LAWRENCE HISTORIC RESOURCES COMMISSION
ITEM NO. 8: DR-04-49-11
STAFF REPORT

DR-04-49-11 1043 Indiana Street; Relocation and New Construction; Certified Local Government Review. The property is located in the environs of the Oread Historic District and the Michael D. Greenlee House (947 Louisiana), National Register of Historic Places. Submitted by Paul Werner Architects for Triple T LLC, the property owner of record.

1 EAST ELEVATION
SCALE: 3/32" = 1'-0"

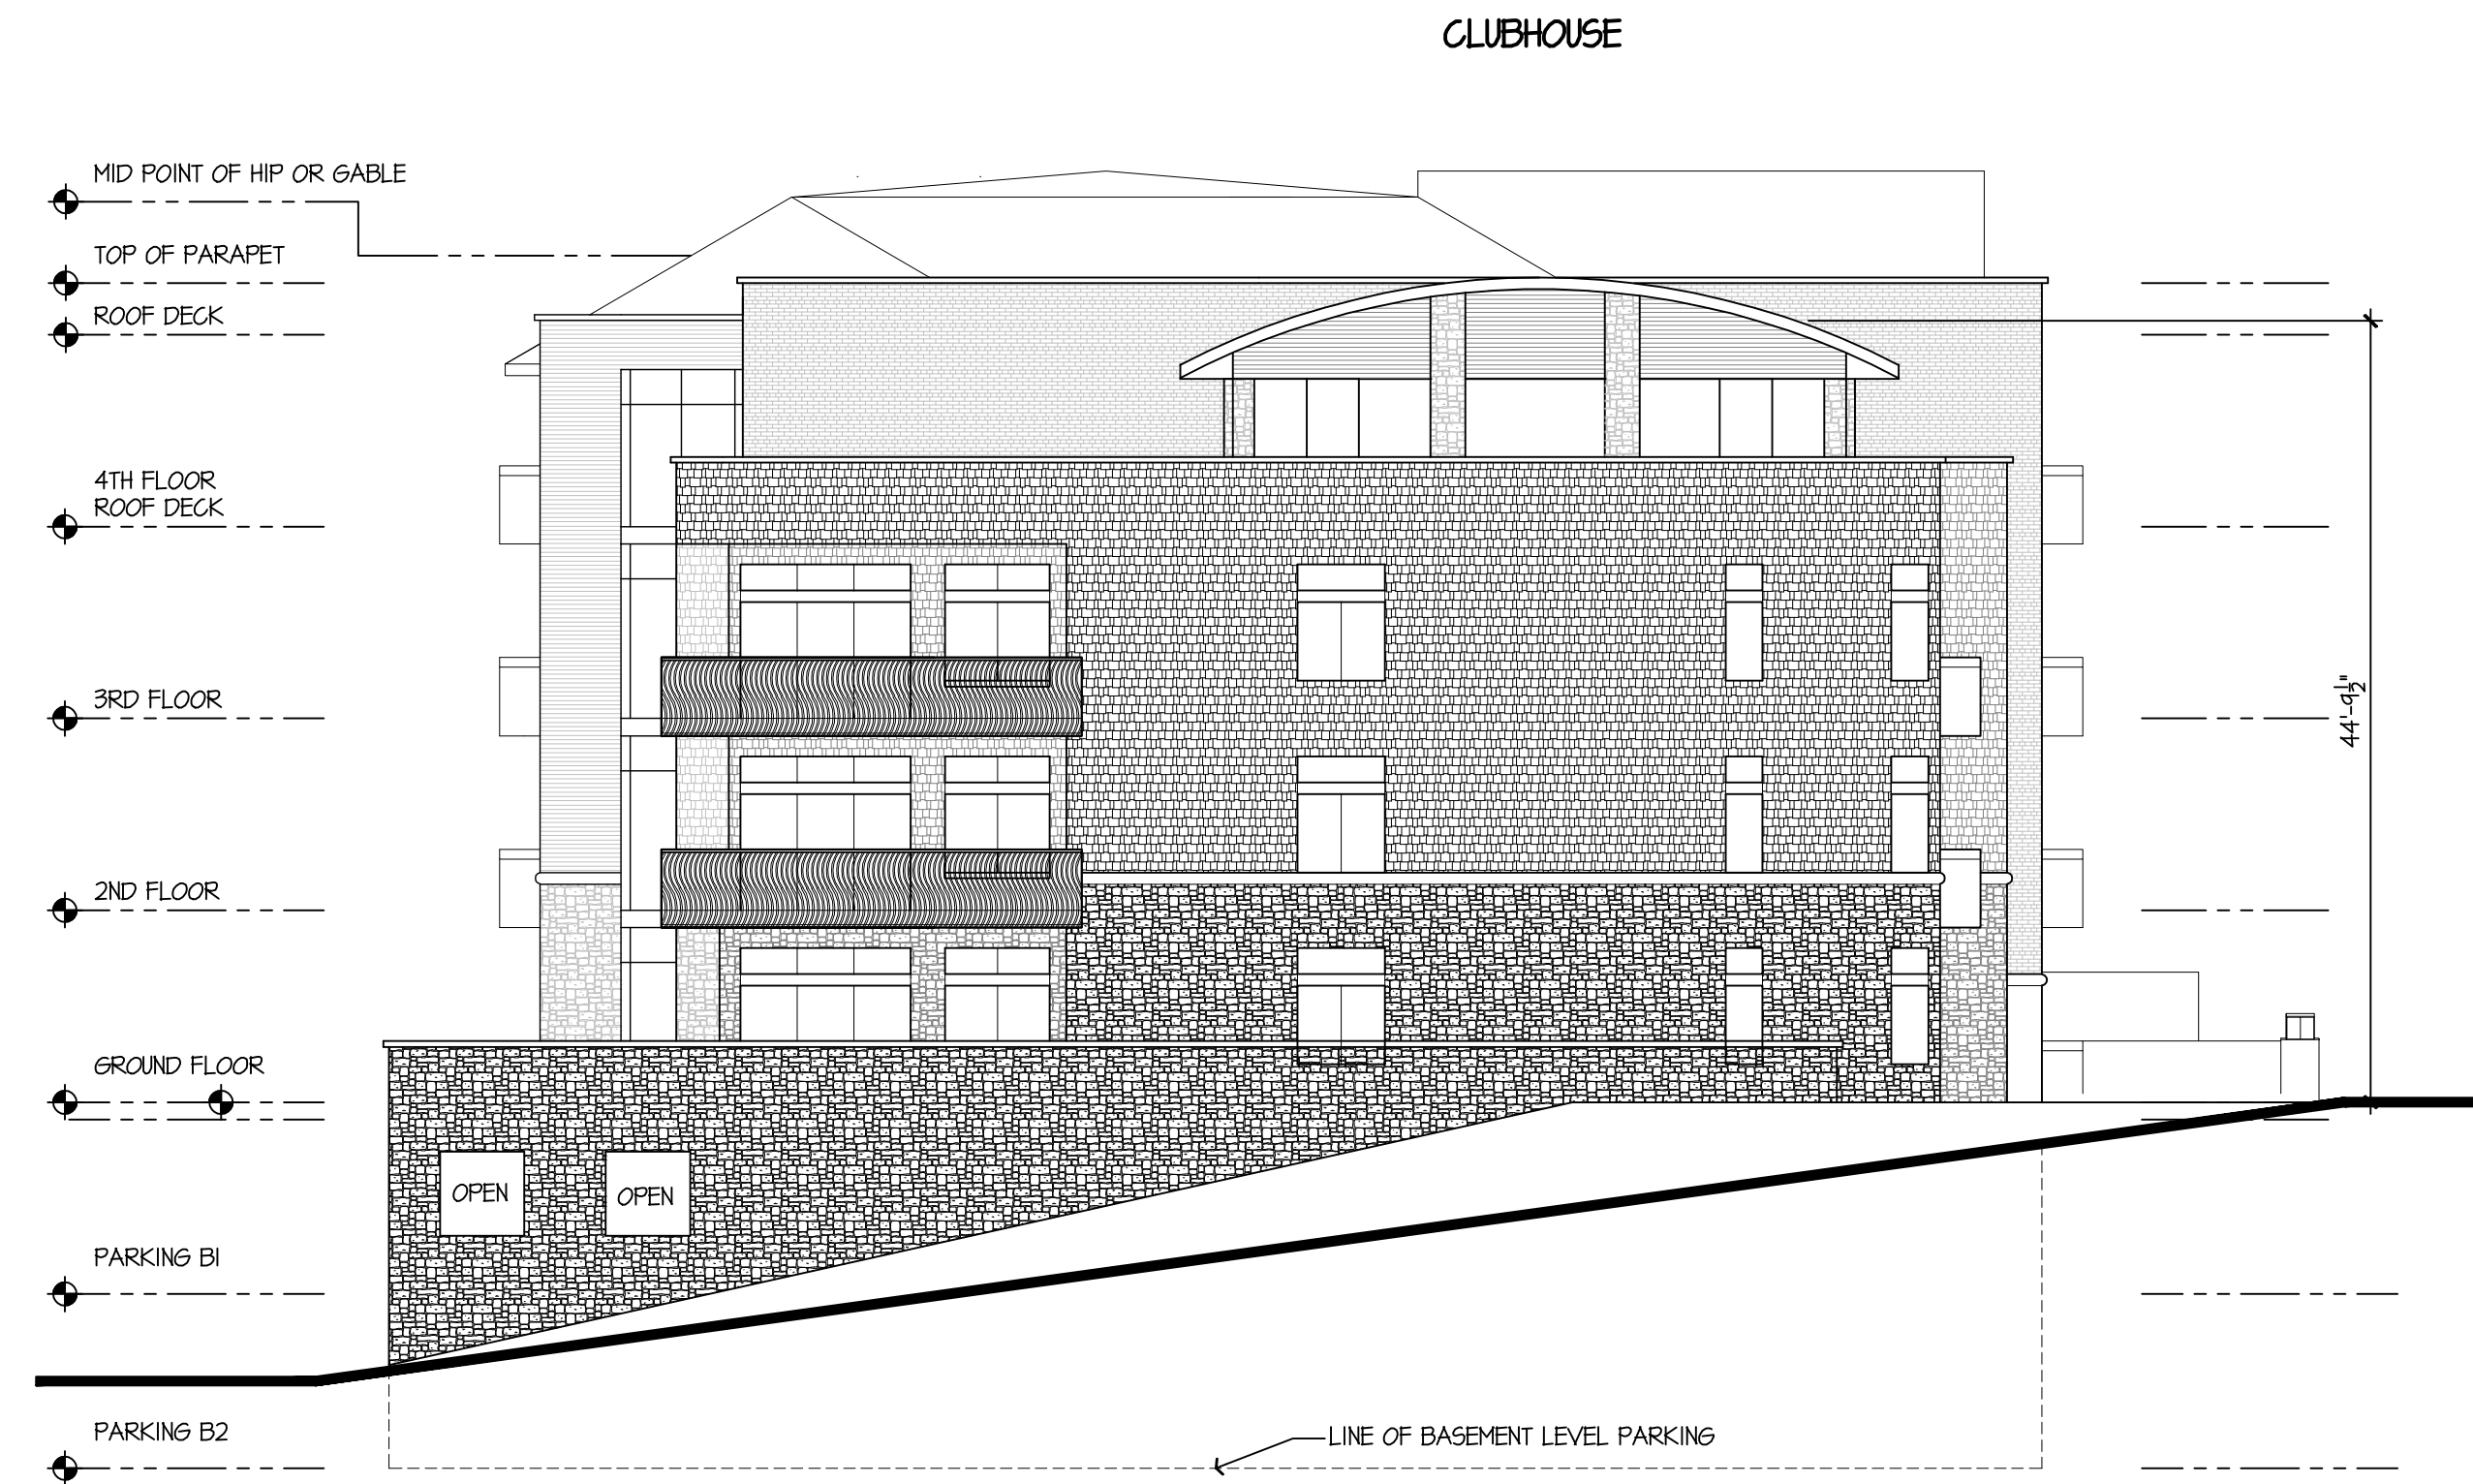
On all sides of the façade are balconies with railings of perforated aluminum and painted steel. Balconies are not common in the environs. The free standing structures typically have front porches and back patios. Occasionally there will be a second floor balcony/porch where a sleeping porch would have been. Even then, those porches are made of stone and wood. The materials portrayed in the renderings do not match those in the neighborhood.

The windows on the proposed building, though an improvement from previous versions, still don't read as residential windows. The casement window with a horizontal crossbar on the top third of the windows does not fit the environs where most windows would be double hung. Additionally, the windows in the new construction are larger than most in the residential environs.

The north elevation best illustrates how the new construction will relate to the historic structure. The applicant's compromise to keep the structure is to move it to the north so it is near structures of similar size and style and can related to the environs that it is a part of. The north elevation shows new construction that is quite a bit taller and larger in scale than its surroundings and does not relate to the moved structure in materials or rooflines. However, various gable rooflines on the proposed structure are similar to other dwellings in the environs.
